Docket Item #11  
BAR CASE# 2004-0112

BAR Meeting  
August 18, 2004

**ISSUE:** Alterations  
**APPLICANT:** Barbara J. Kaye  
**LOCATION:** 420 Gibbon Street  
**ZONE:** RM Residential

The applicant is requesting approval of a Certificate of Appropriateness for alterations to the residence at 420 Gibbon Street.

**Figure 1** Existing west elevation

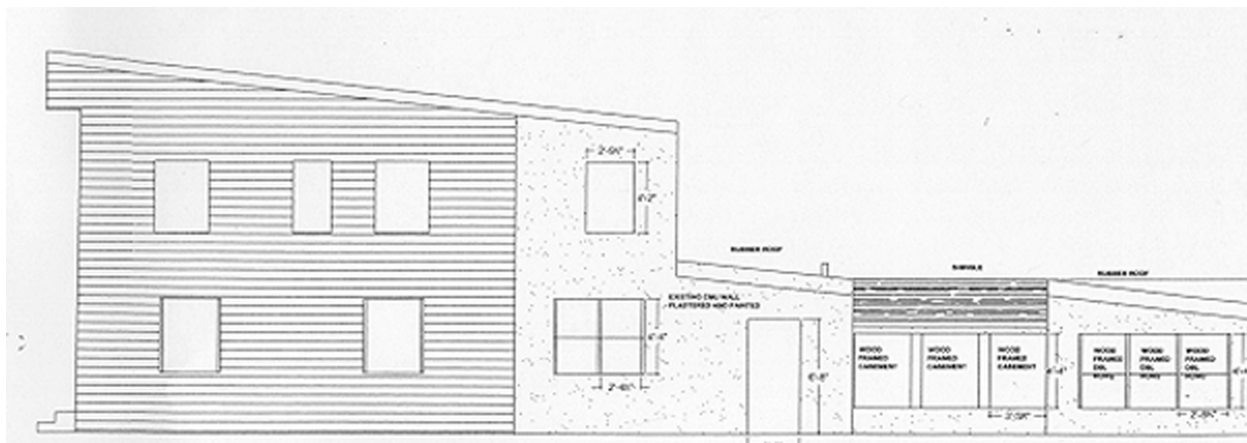
The applicant is proposing to reconfigure the existing rooflines of the rear single story additions. The rear of 420 Gibbon Street is comprised of three separate 20<sup>th</sup> century additions all with different rooflines. The additions will be combined with a single flat roof.

The proposed alterations to the rear additions of the property will be minimally visible through a small gap between 420 Gibbon and its neighbor 422 Gibbon to the west. Staff has no objections to the alteration of the rooflines of the rear additions. The additions were all constructed in the 1950s and appear to have been poorly constructed.

**Figure 2** Proposed west elevation

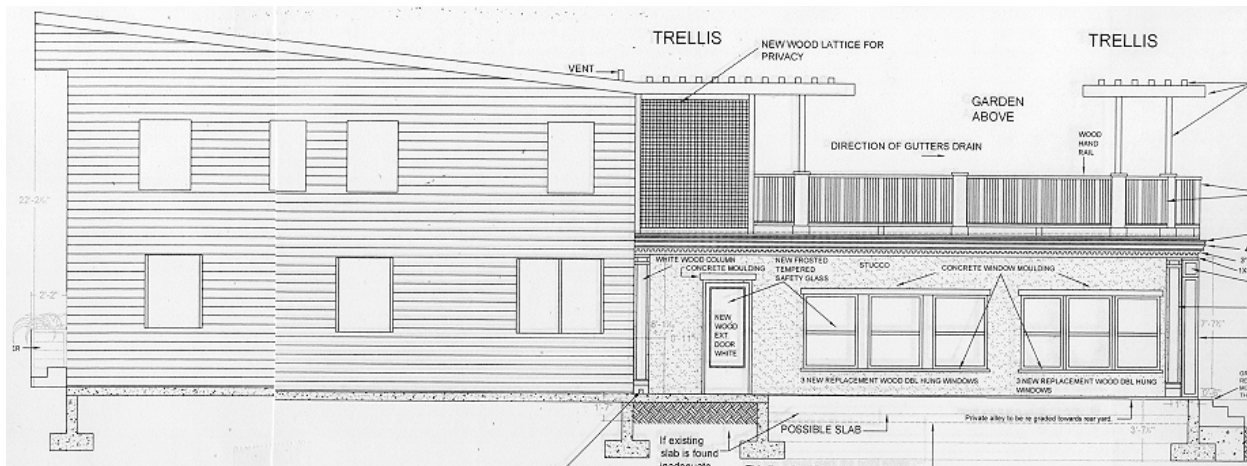
1. That the new wooden columns on the west elevation be recessed so as not to project beyond the property line;
2. That the trellis not extend over the property line;
3. That the rear trellis match the trellis drawn on the “New Section A” with the second baluster located at the corner of the roof; and,
4. That the column on the southern end of the west elevation be located at the edge of the addition where the new transom and door is drawn on the “New Side Elevation”.

1. That the new wooden columns be recessed so as not to project beyond the property line;
2. That the trellis not extend over the property line;
3. That the southern trellis match the trellis drawn on the "New Section A"; and,
4. That the column on the southern end of the west elevation be located at the edge of the addition where the new transom and door is drawn on the proposed elevation.
